HISTORIC LANDMARK COMMISSION
APPLICATION FOR A CERTIFICATE OF APPROPRIATENESS
AUGUST 2, 2023
HR-2023-087085
SMOOT-TERRACE PARK HISTORIC DISTRICT
605 HIGHLAND AVENUE

PROPOSAL

Rehabilitate a contributing house.

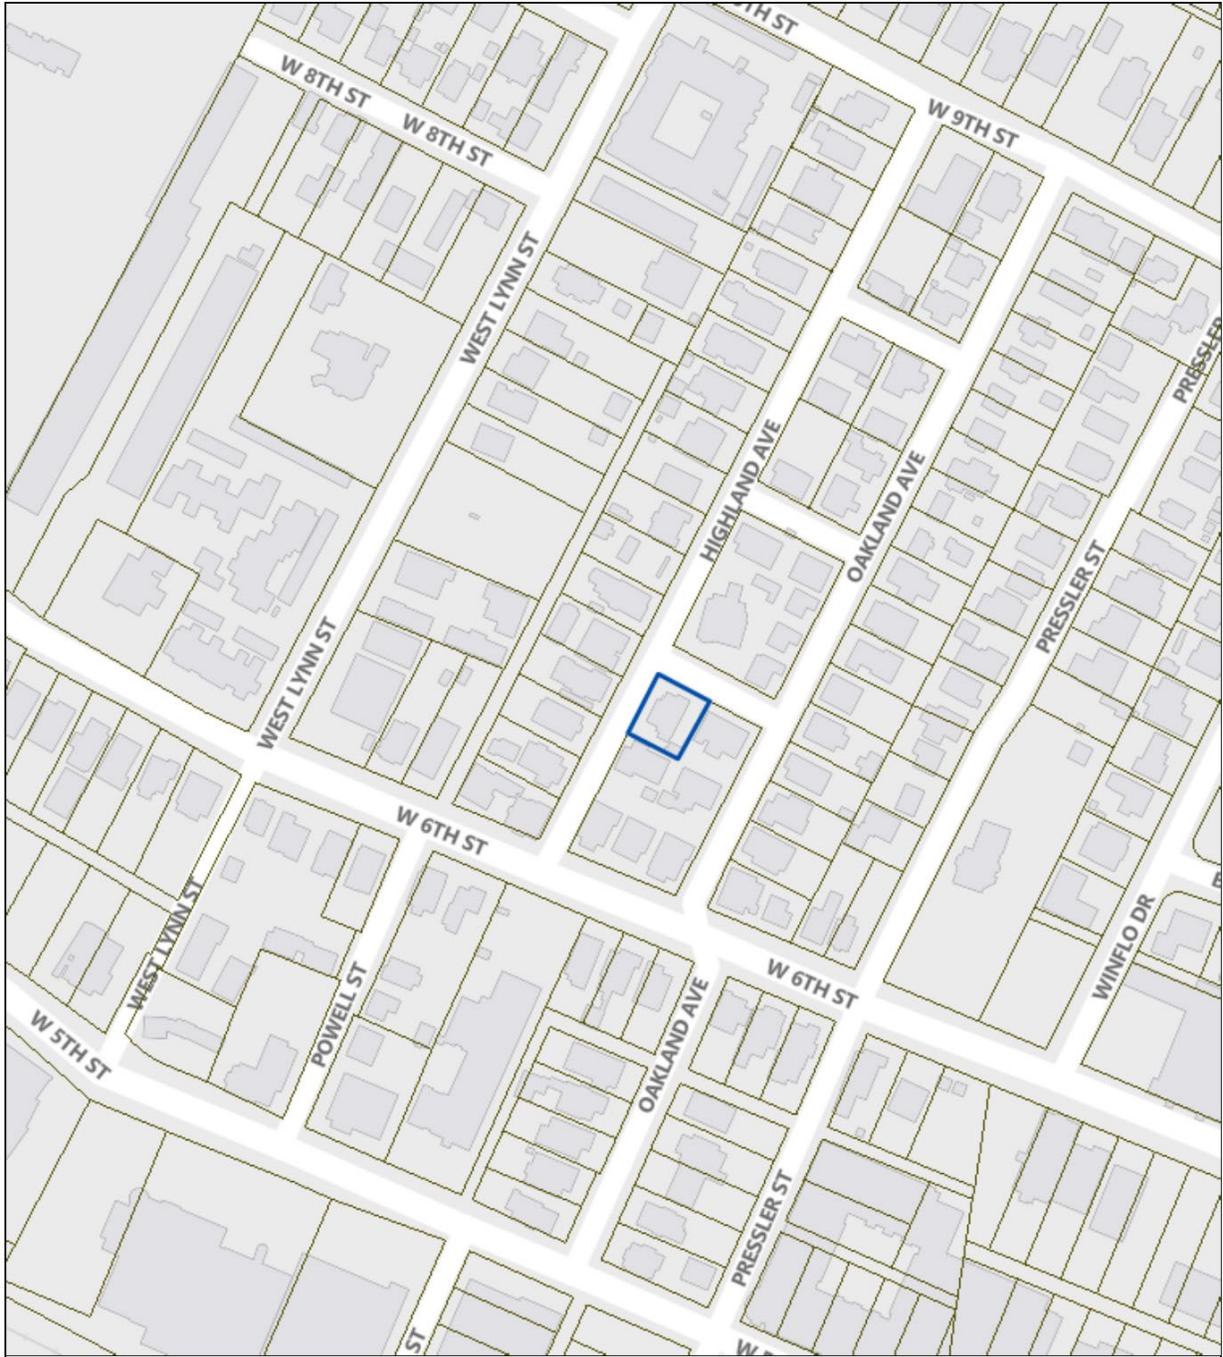
Consider removal of the door hood, or make it easily removable. Do not change or create window openings.

Approve the application with the request that the door hood be constructed to remove as little historic fabric as possible if removed or replaced in the future.
